Our Ref: 304600730-L02: BCP/bcp
Contact: Dr Brett C. Phillips

**ADDENDUM TO STAGE 1 FLOOD IMPACT ASSESSMENT
SSD-9138102 WESTLINK INDUSTRIAL ESTATE AT 290-308 ALDINGTON ROAD,
59-62 ABBOTTS ROAD & 63 ABBOTTS ROAD, KEMPS CREEK**

MAMRE ROAD PRECINCT STORMWATER SCHEME PLAN

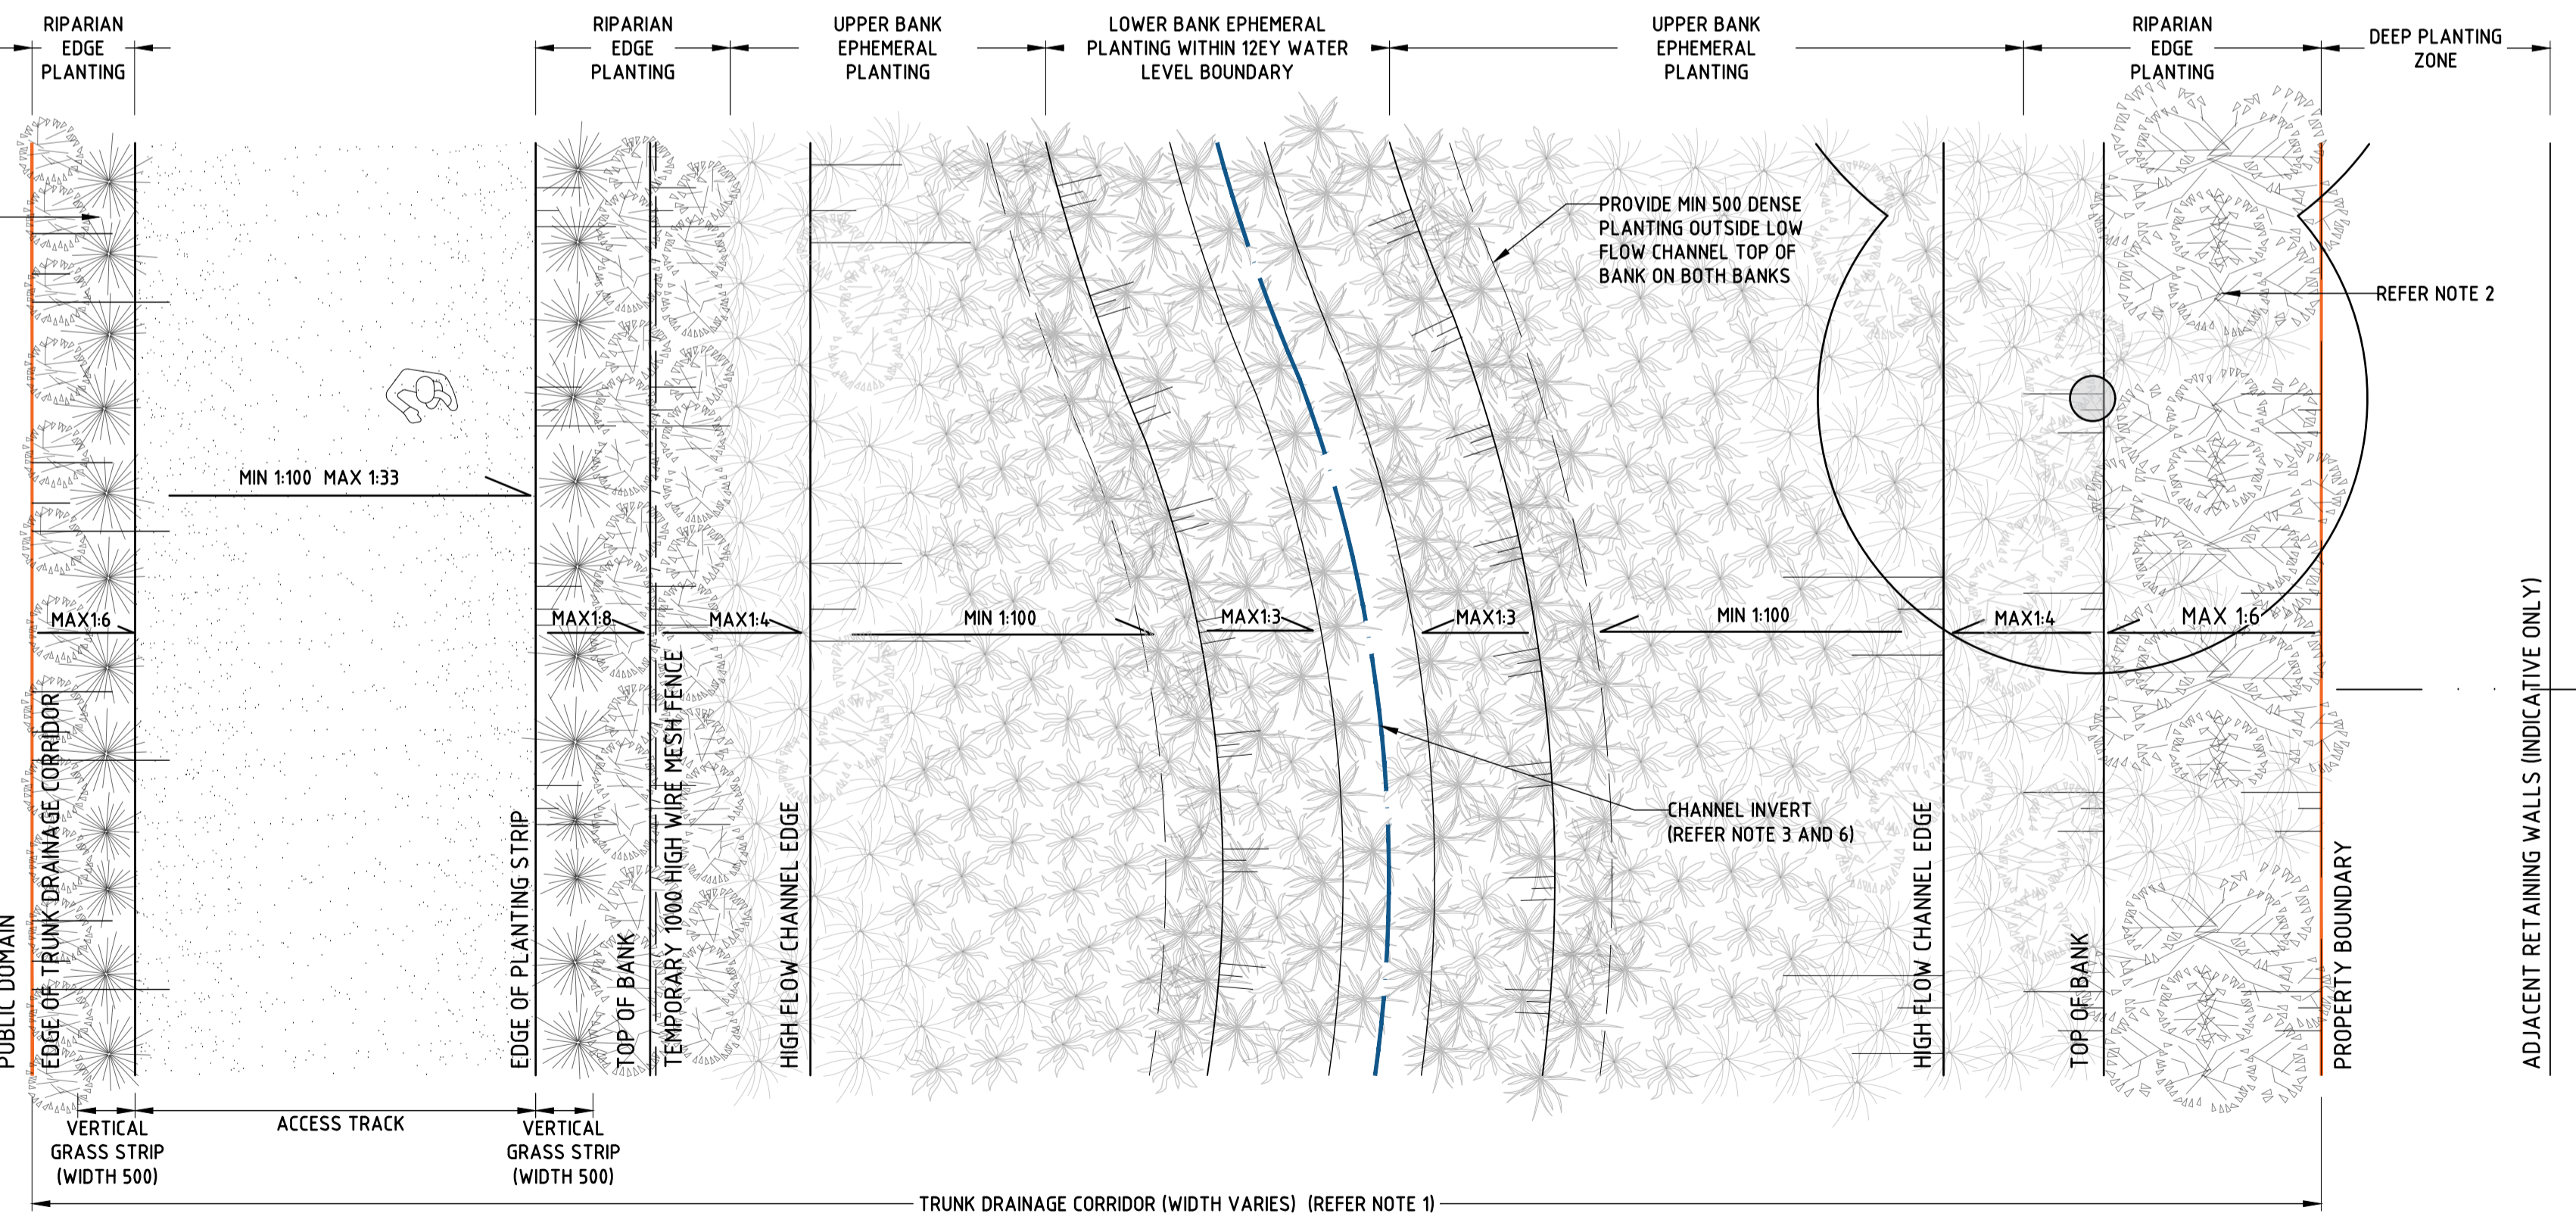
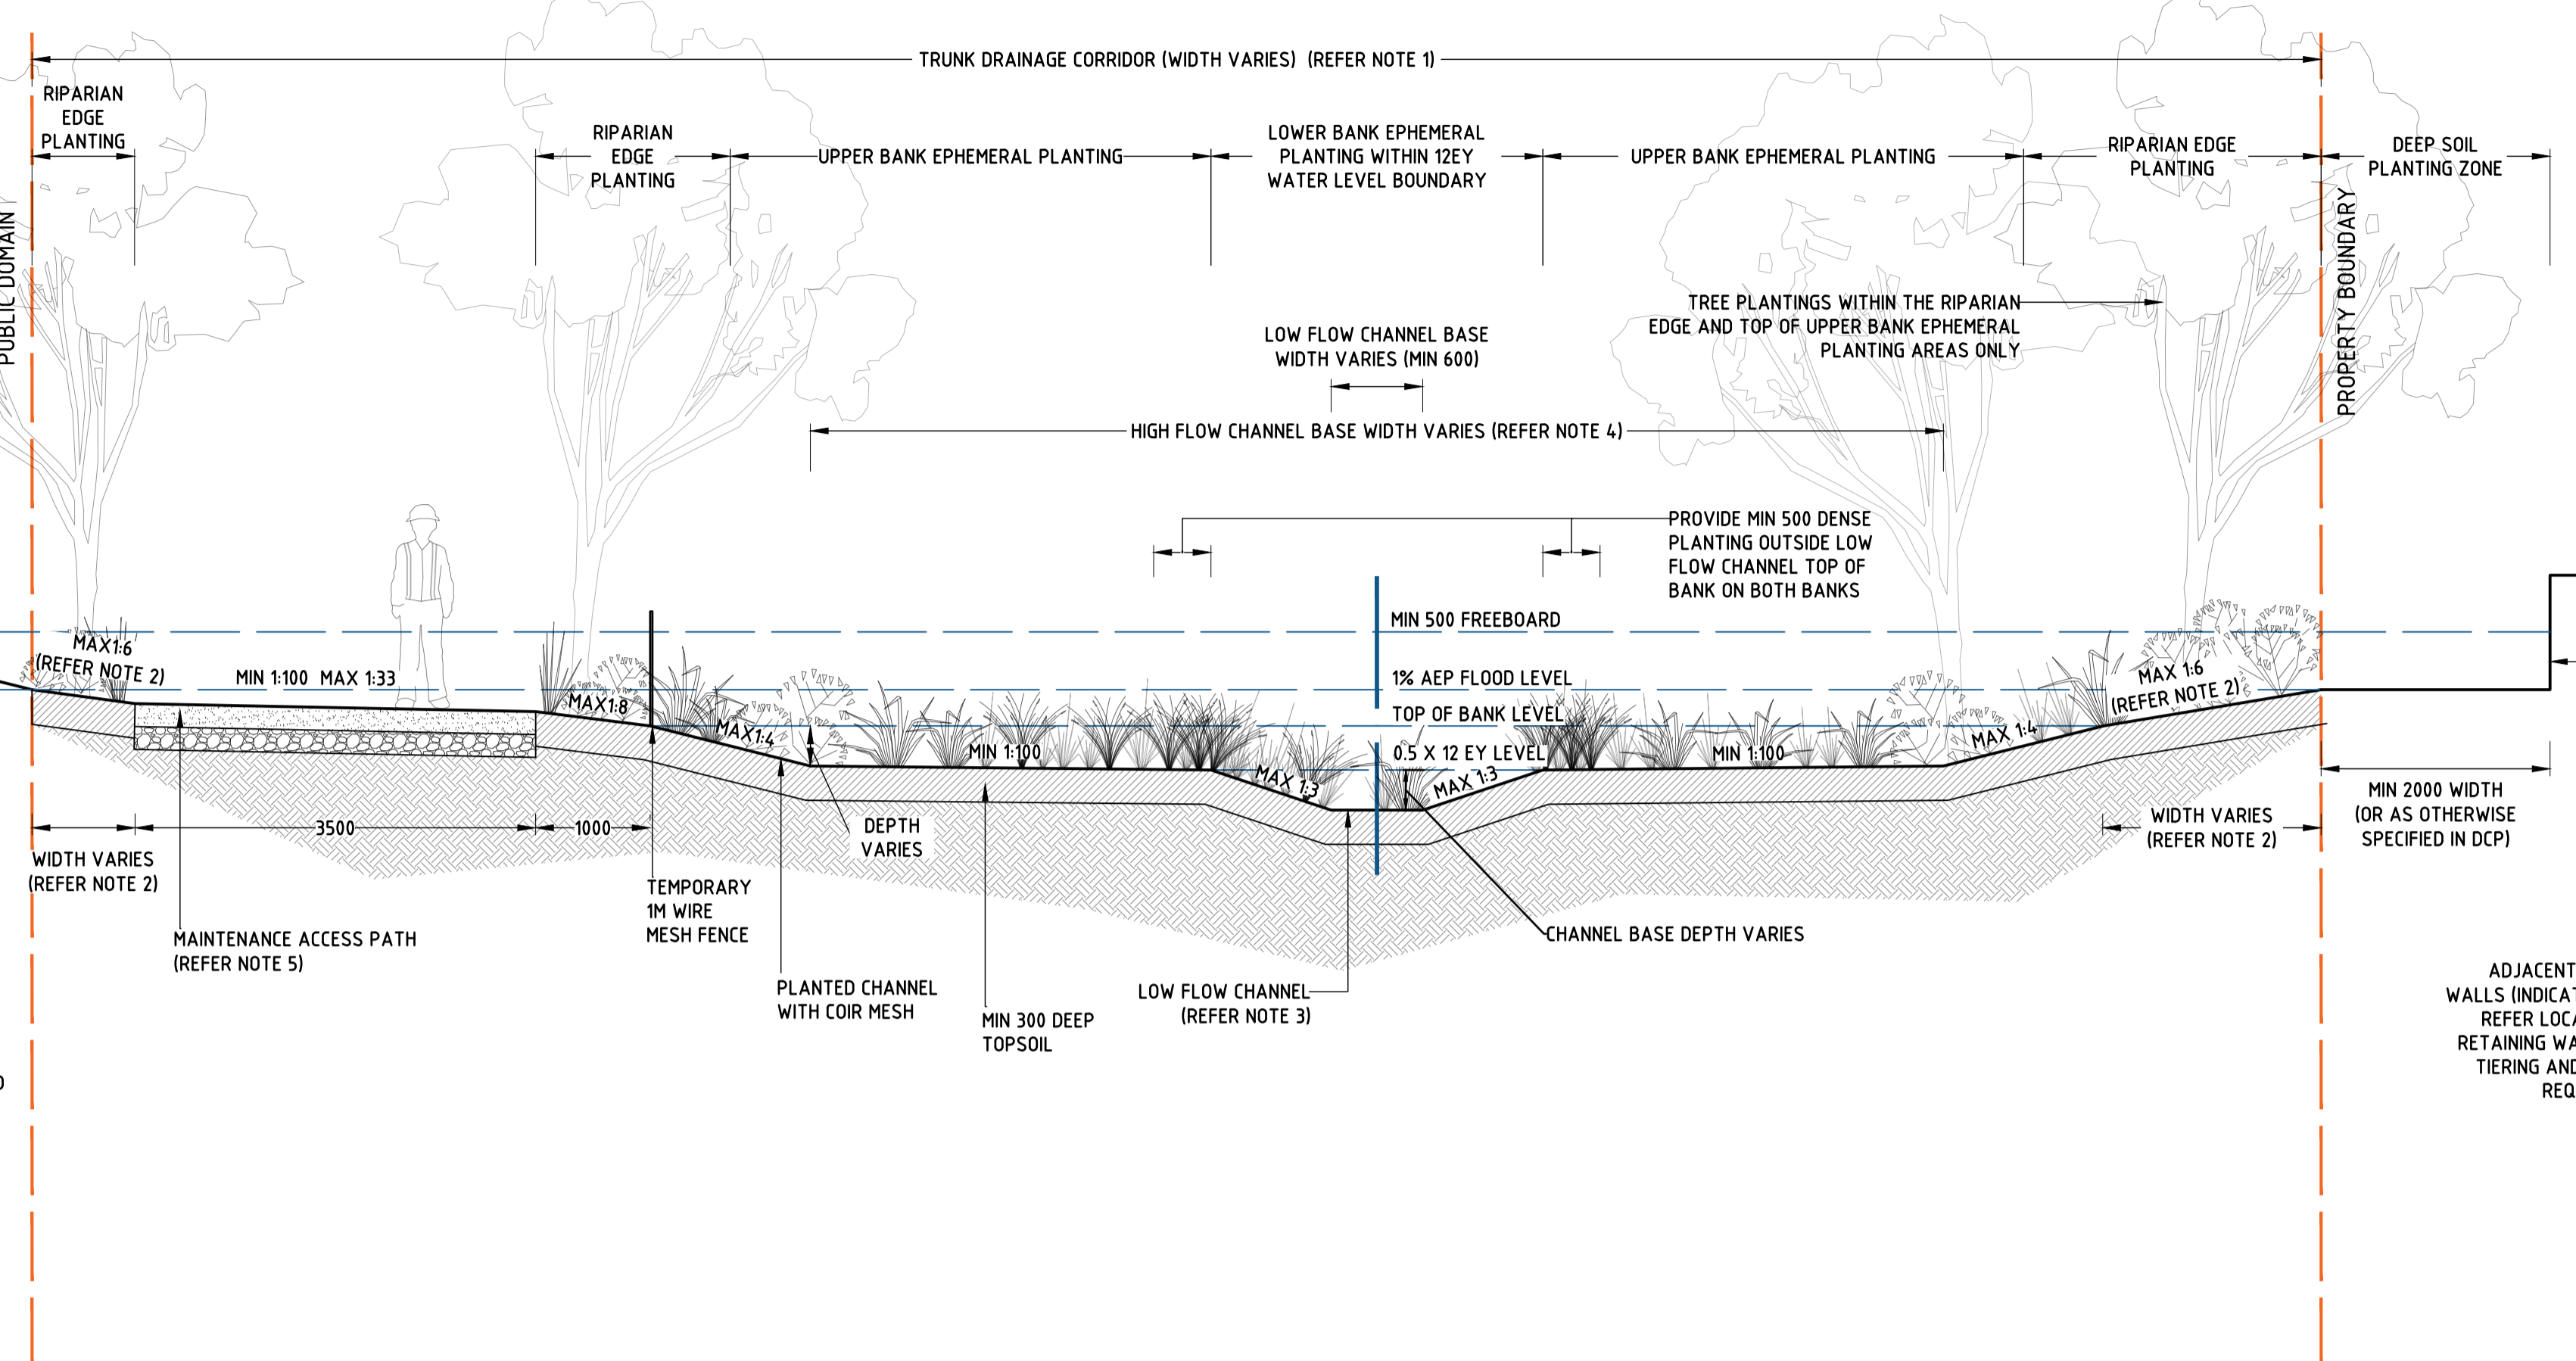
The updated draft Stormwater Scheme Plan is appended in **Attachment A1**. It is overviewed as follows:

This Stormwater Scheme Plan shows the regional stormwater infrastructure required to service the Mamre Road precinct and to be managed by Sydney Water.

**TRUNK DRAINAGE CHANNEL TYPICAL 1
PLAN AND SECTION**

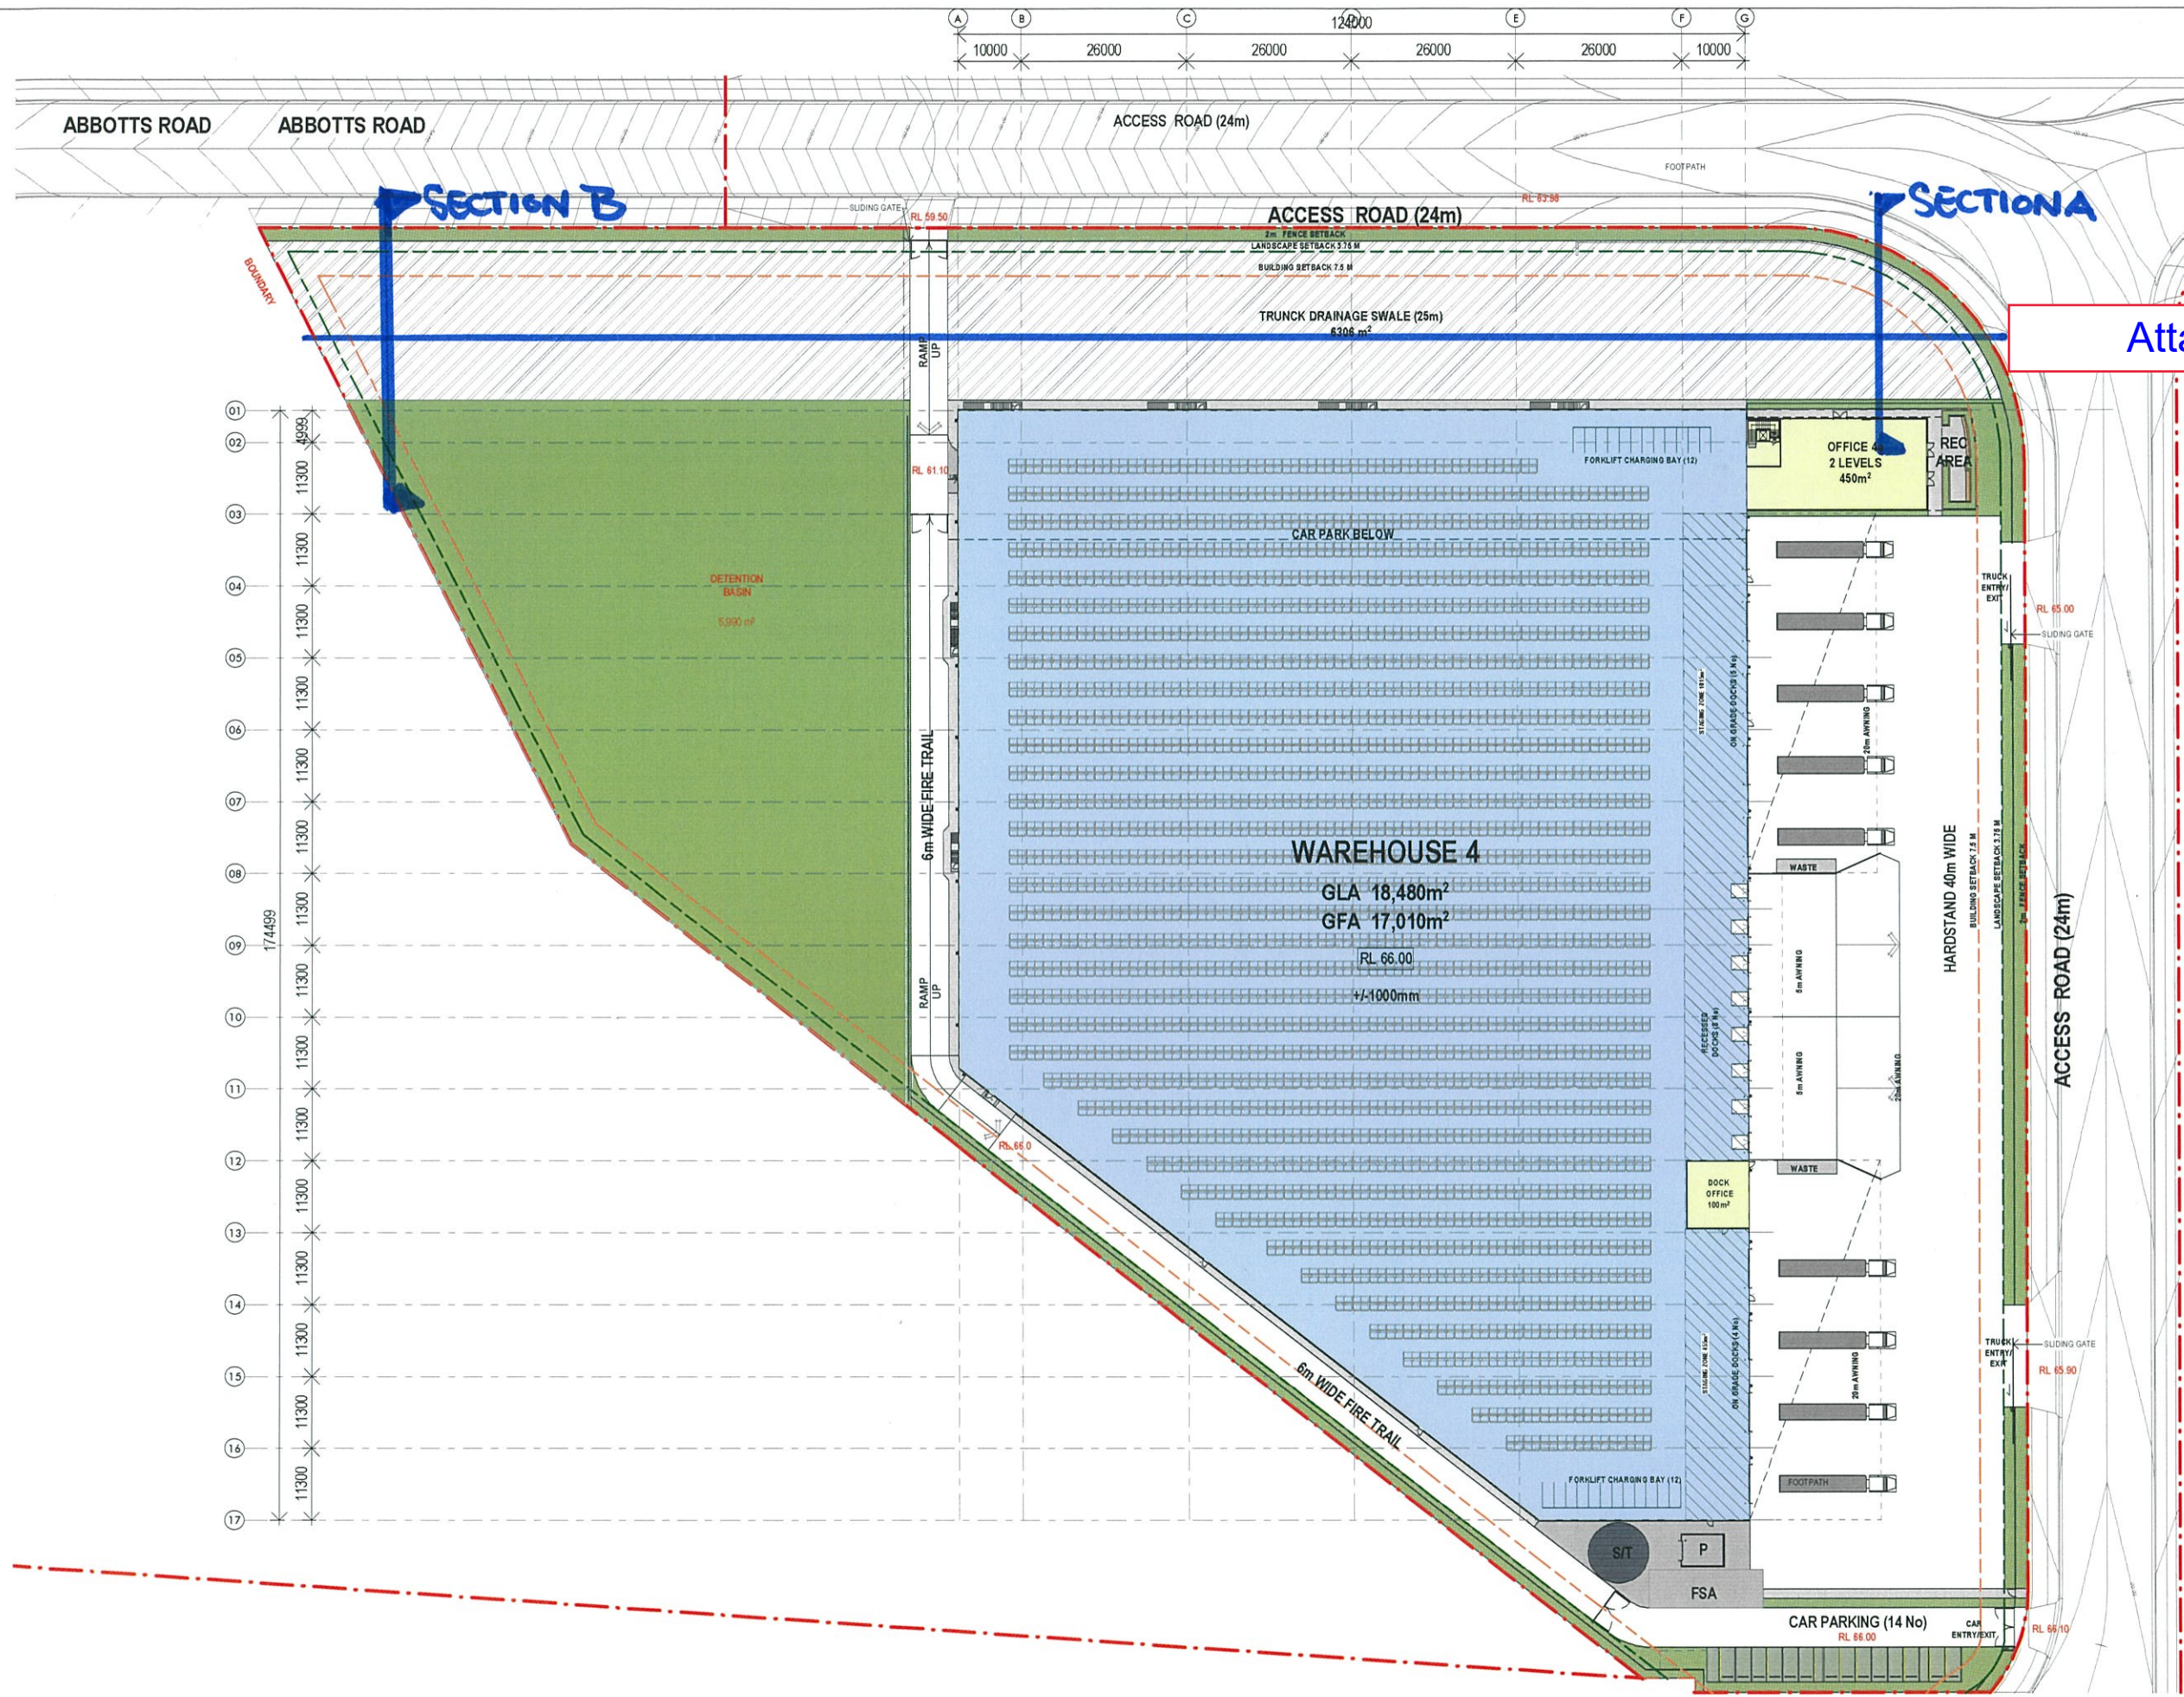
The alignment of the proposed trunk drainage channel in Stage 1 is identified in **Attachment B**. It is proposed that the channel geometry be based on the Type 1 geometry set out in **Attachment A2**.
